P0766-0009

**Re: Request for Wetlands Conditional Use Permit Review
1 Franklin Ave - New Franklin School Upgrades**

To: Kate Homet, Environmental Planner & Sustainability Coordinator

C-600

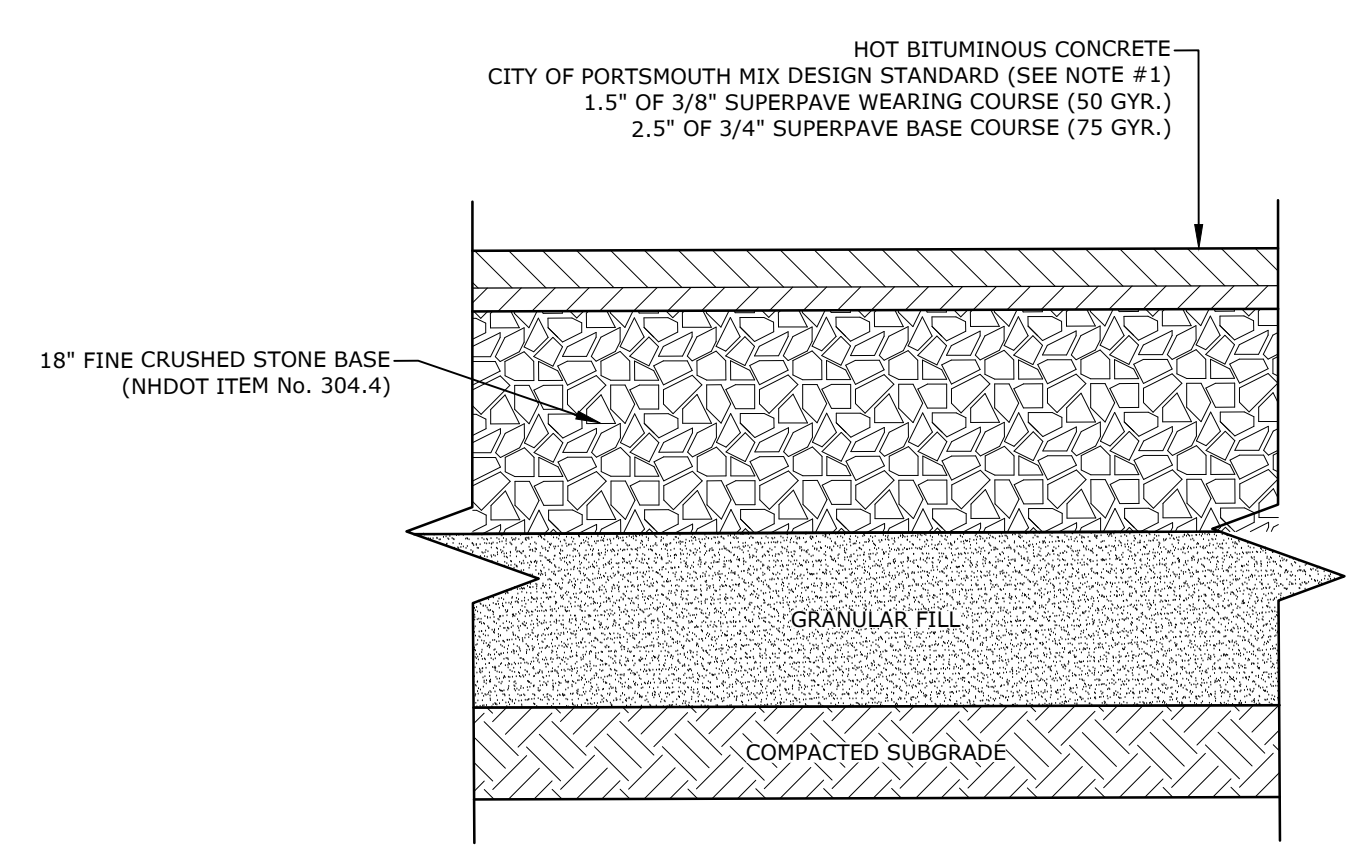
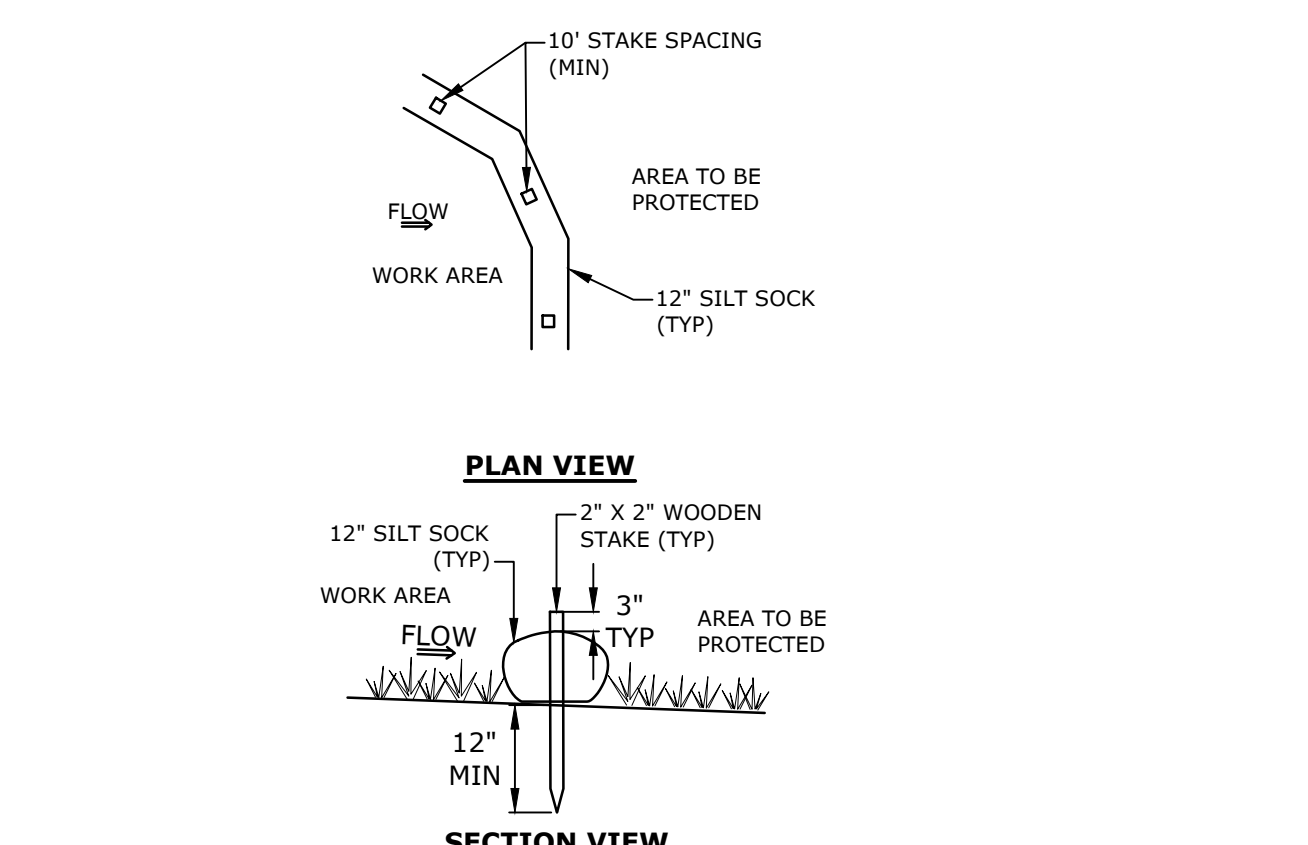
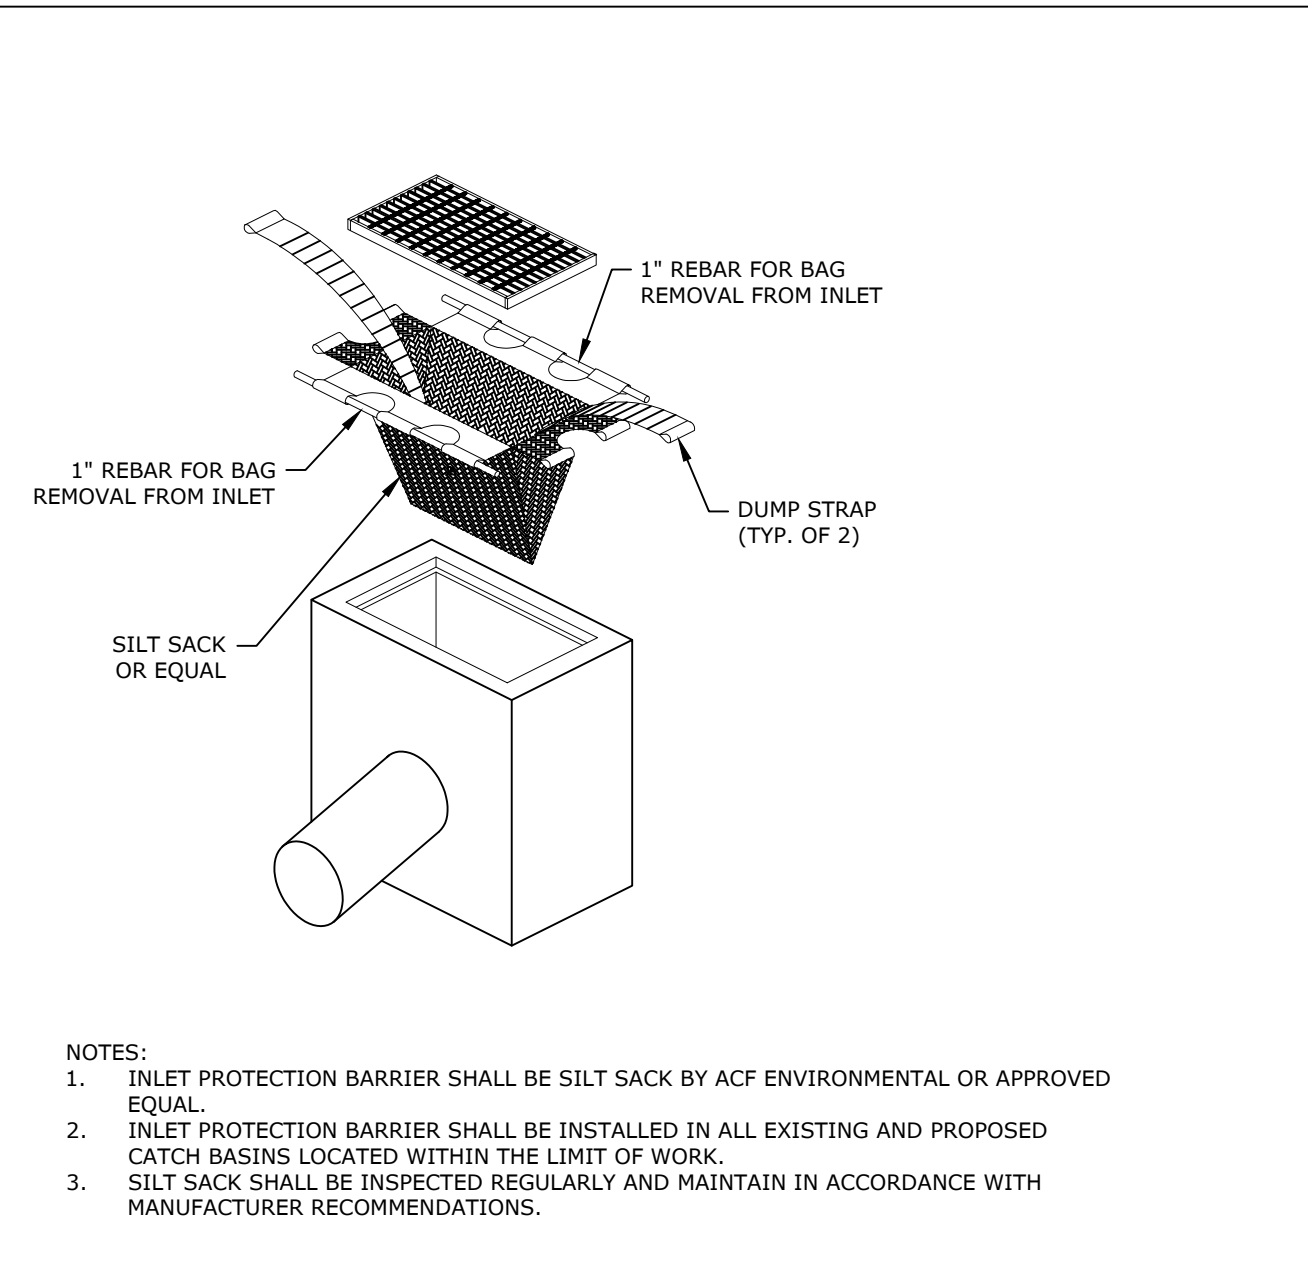
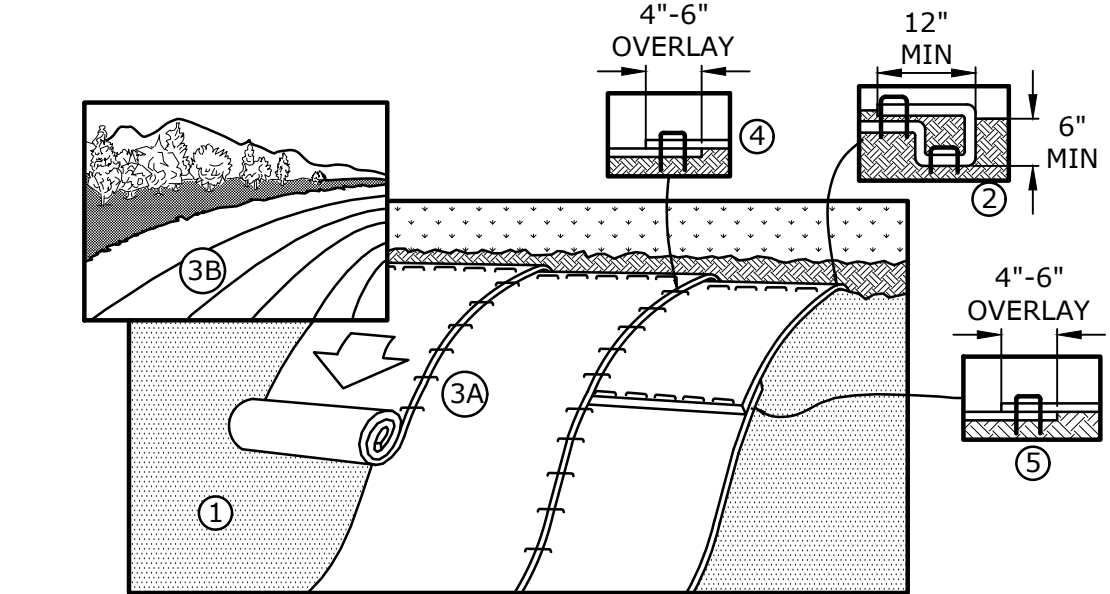
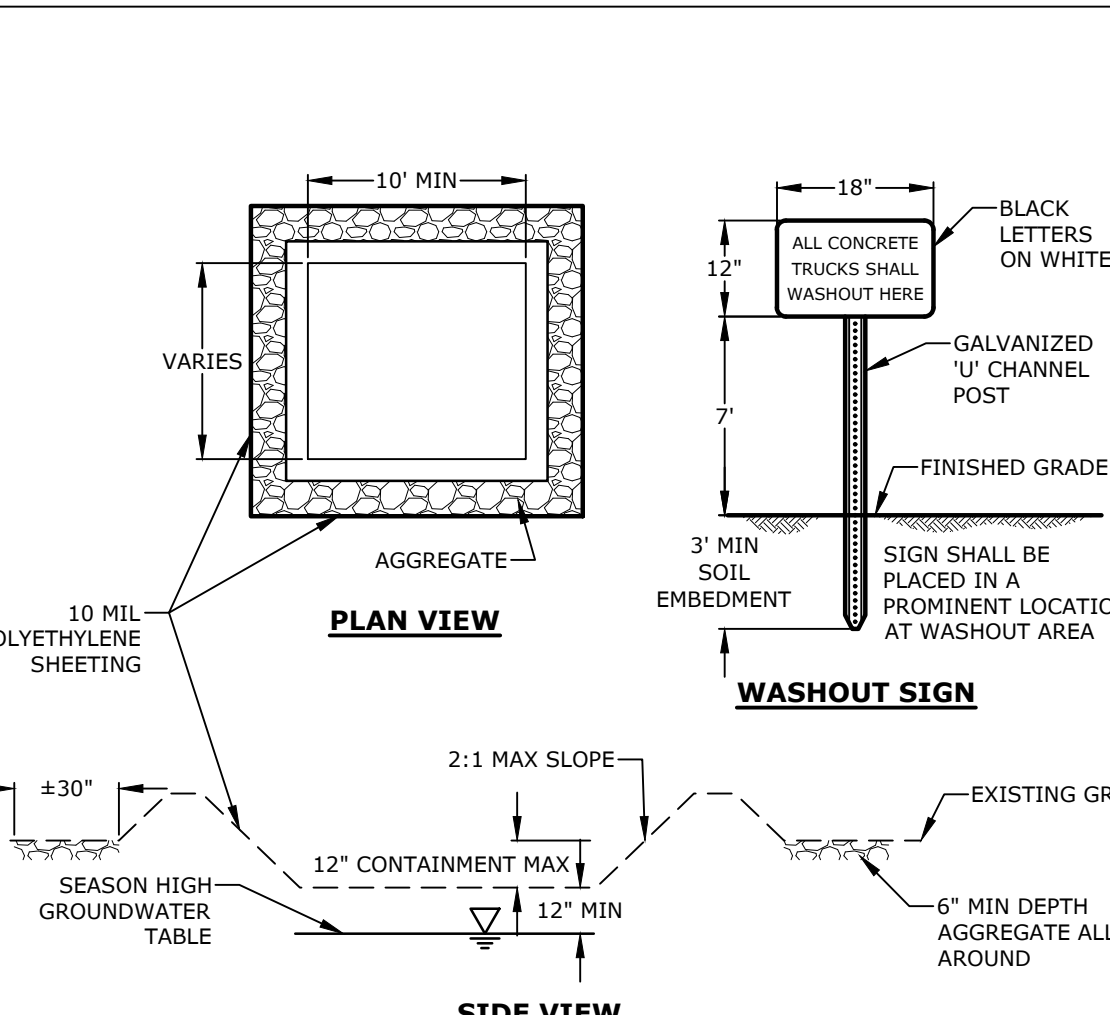
- 4. Please include a detail sheet for the planned erosion controls.**

Please see sheet C-600 "Erosion Control Notes & Details Sheet" included in the original submission.
